ALERT SERVICE BULLETIN

ASB No. AA-09002

SUBJECT: **Passenger Shoulder Harness Kit**
P/N 206-936-700 / 206-936-701 / 206-936-702
Passenger Shoulder Harness Installation
P/N 206-931-100 / 206-931-200 / 206-931-300
Passenger Shoulder Harness R/H Installation
P/N 206-931-102

DESCRIPTION: This Alert Service Bulletin is being issued in
response to reports of Aft Passenger Shoulder
Harness Kit Angle Mount [P/N 206-930-122 (R/H)]
radius bend cracking.

FIGURE 1 – ANGLE MOUNT [206-930-122 (R/H)] – CRACKING SHOWN

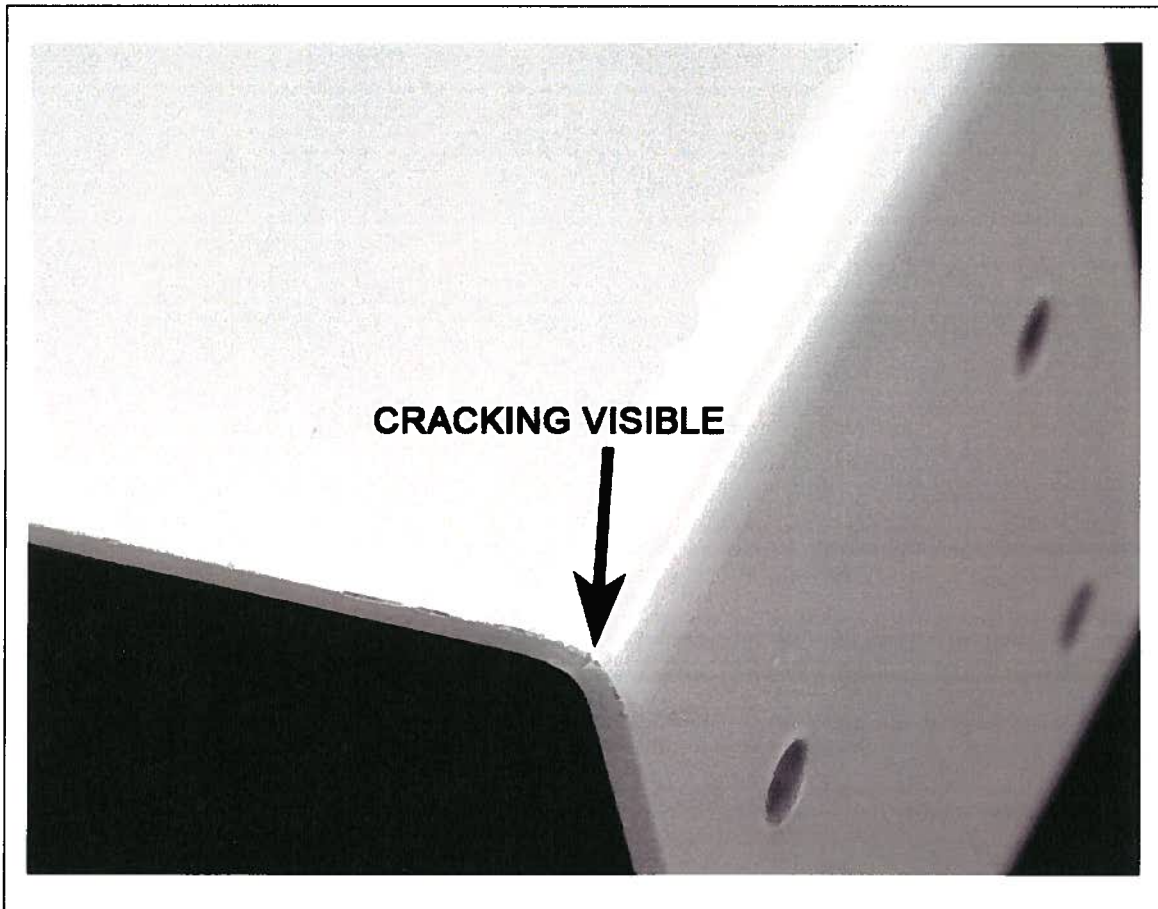
1. Remove and retain the Screws (120-079-6-12) and Washers (601-6) securing Adapter [206-930-136 (R/H)] to the hat bin.
2. Position Adapter so that radius bend of Angle Mount [206-930-122 (R/H)] is visible through opening.
3. Using at least 10X magnification and a strong light source, visually inspect the radius bends for indications of cracking. If cracking is suspected, remove and retain screws securing hat bin to gain access to Angle Mount [206-930-122 (R/H)] and reinspect radius bend.

IF CRACKING IS DISCOVERED, THE ANGLE MOUNT IS NO LONGER AIRWORTHY AND MUST BE IMMEDIATELY REPLACED. REPLACE ANGLE MOUNT PER INSTRUCTIONS IN PART II, ANGLE MOUNT REPLACEMENT INSTRUCTIONS.

1. If not previously removed, remove and retain screws securing hat bin to gain access to Angle Mount [206-930-122 (R/H)].
2. Remove and retain Screws (MS24694) securing Shoulder Harness to Angle Mount [206-930-122 (R/H)], Spacer (206-930-123), Doubler (206-930-114), and Spacer (206-930-125) to detach Shoulder Harness from Angle Mount [206-930-122 (R/H)].
3. Remove Rivets (CR3243) securing Angle Mount [206-930-122 (R/H)] and Shim (206-930-128) to bulkhead. Remove and retain Shim. Return removed Angle Mount to:
Aeronautical Accessories, Inc.
ATTN: Quality Dept.
441 Industrial Park Road
Piney Flats, TN 37686
4. Rivet replacement Angle Mount [206-930-122 (R/H)] and Shim (206-930-128) to bulkhead.

5. Reattach Shoulder Harness to Angle Mount [206-930-122 (R/H)] using retained Screws (MS24694), Spacer (206-930-123), Doubler (206-930-114), and Spacer (206-930-125).
6. Reinstall hat bin using retained screws and washers.
7. Annotate records to indicate accomplishment of this bulletin. Return aircraft to service.
